# PRELIMINARY CONCEPT LANDSCAPE / BUFFER PLAN

11910 Green Acres Lane | Lot 2 Treasured Acres Filing No. 1

Preliminary concept for formal drafting and field verification

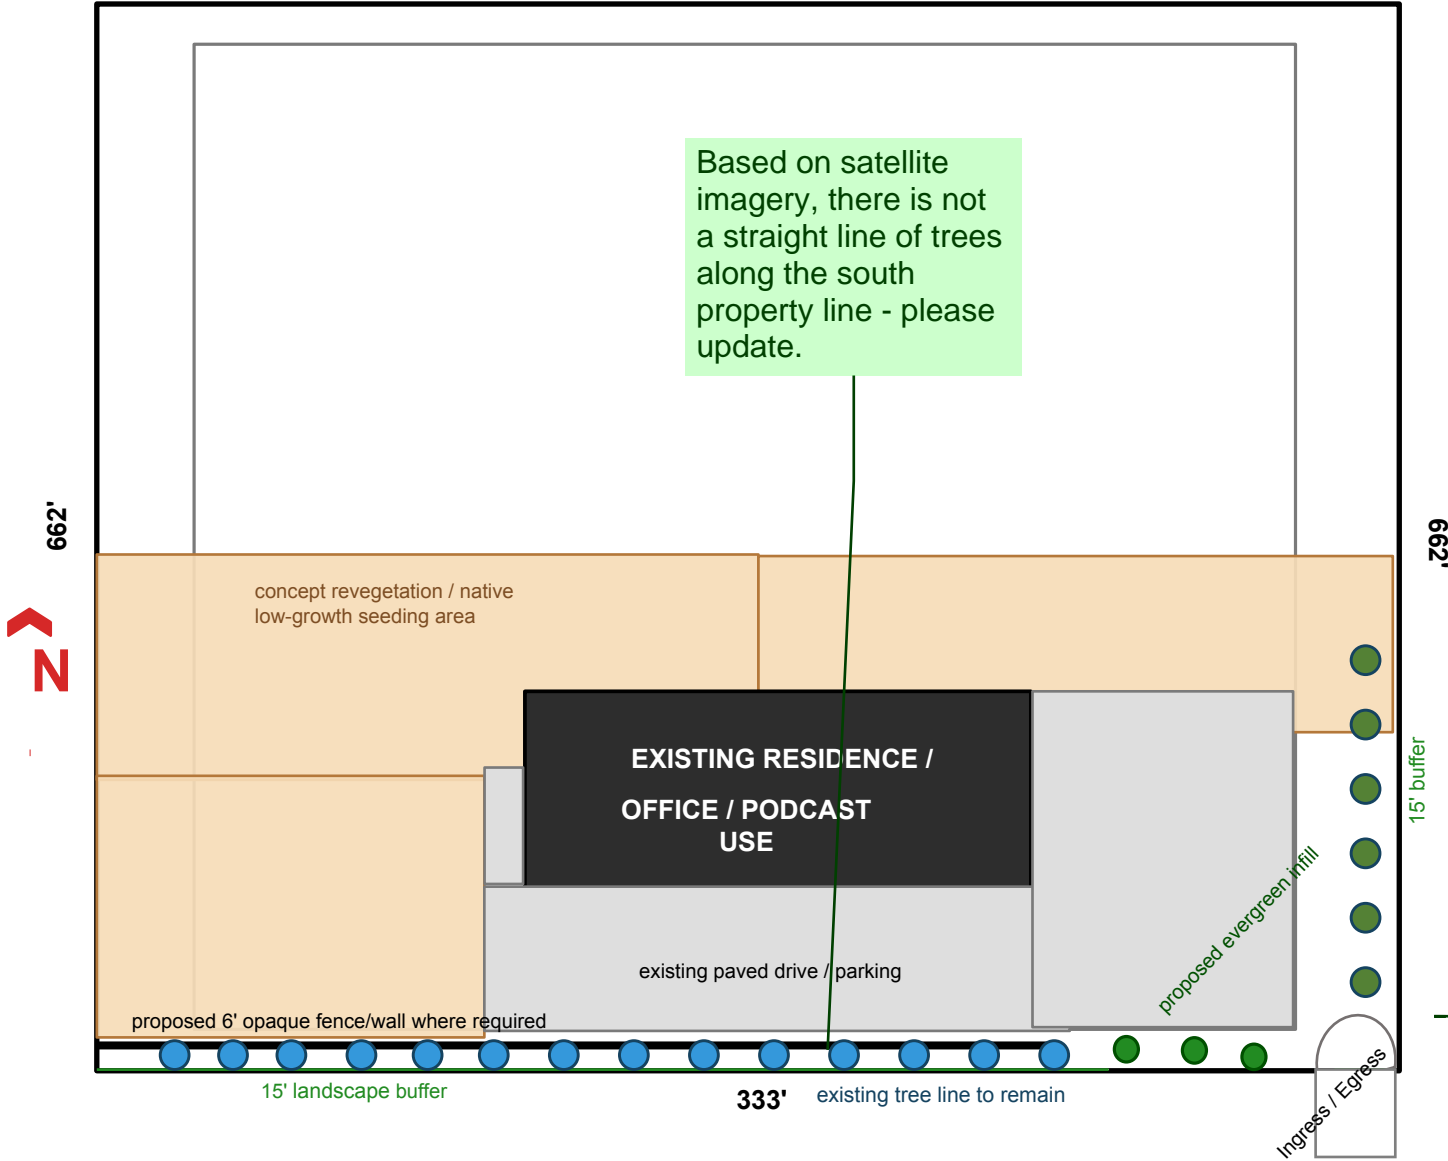
Add the title block that you have on your other documents with applicant info, parcel number, etc. Include Project Name and Number - 11910 Green Acres Land Variance of Use and VA263

Include table with required landscaping compared to proposed landscaping. Trees required at a rate of 1 tree per 25'.

Based on satellite imagery, there is not a straight line of trees along the south property line - please update.

This drawing is not to scale or proportional, so it would not be accurate to include a scale.

Fence needs to buffer from this non-residential use to residential zoning. You are surrounded by residential zoning on all sides. I'm willing to look at not buffering to the north based on the activity being focused to the south, but we do need more buffering than is currently shown, and it should be explained in the letter of intent why the buffering is limited to the south portion of the lot. Please be advised, Commissioners may add a condition of approval that the entire property be screened.
